TECHNICAL EVALUATION REPORT

MASONRY WALL DESIGN

DUKE POWER COMPANY

OCONEE NUCLEAR STATION UNITS 1, 2, AND 3

SCHEMATIC REPRESENTATION OF WALL MODIFICATIONS

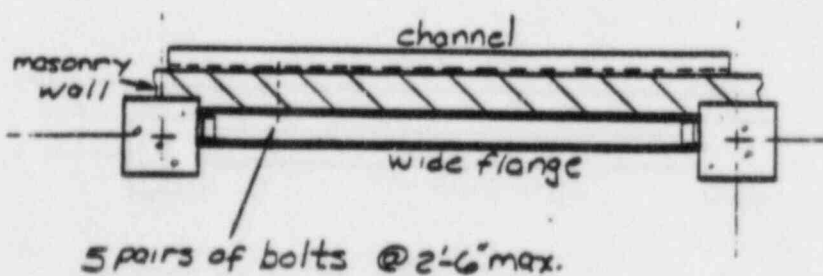
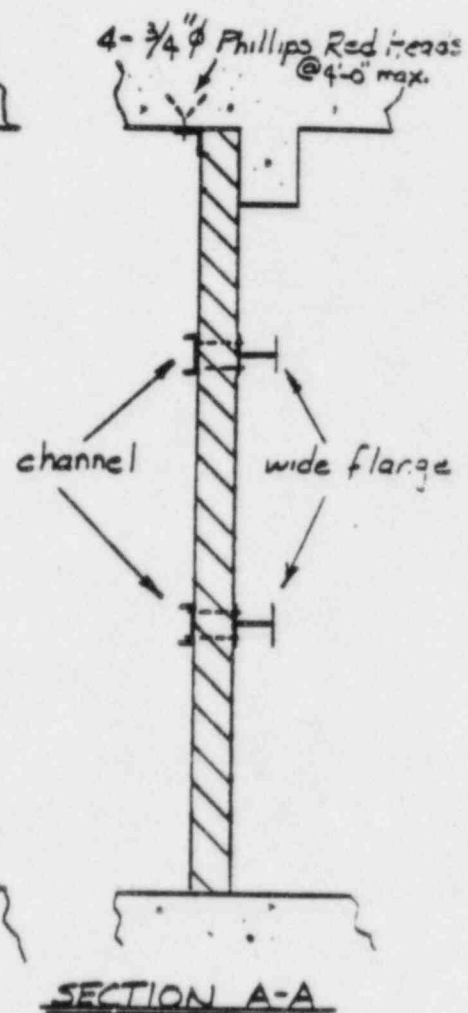
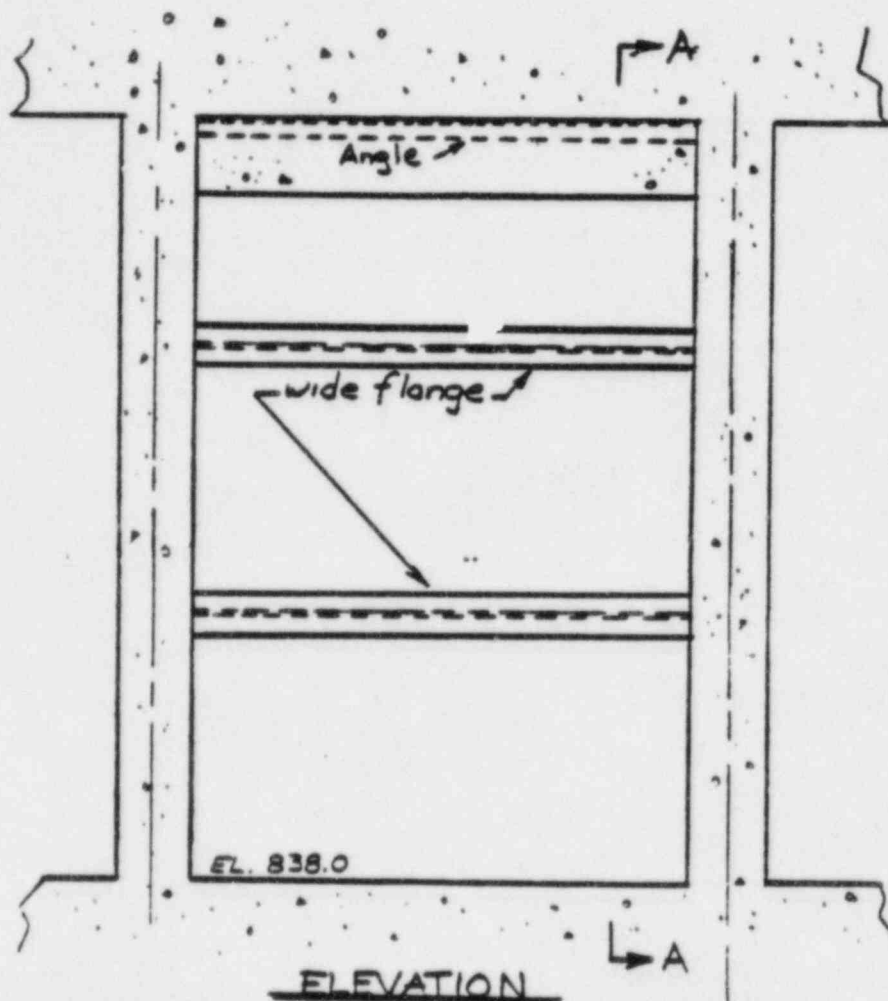
Provide details of proposed wall modifications with sample drawings and explain, using sample calculations, how these modifications will rectify the wall deficiencies. Also, provide a status report for the proposed wall modifications.

The Licensee's response indicated that the modifications have been instituted to provide an added margin of safety for several of the walls that are generally taller than normal and/or experience greater seismic acceleration and that there are no modifications to bring the walls' responses within the Licensee's acceptance criteria.

The Licensee has provided a typical modification in which steel beams have been placed horizontally to reduce the vertical span and hence reduce the bending moment of the wall. (See Appendix D for a schematic representation of wall modification.)

Since no actual modification was needed to bring the wall within the design allowable, it is concluded that the concern has been resolved satisfactorily.
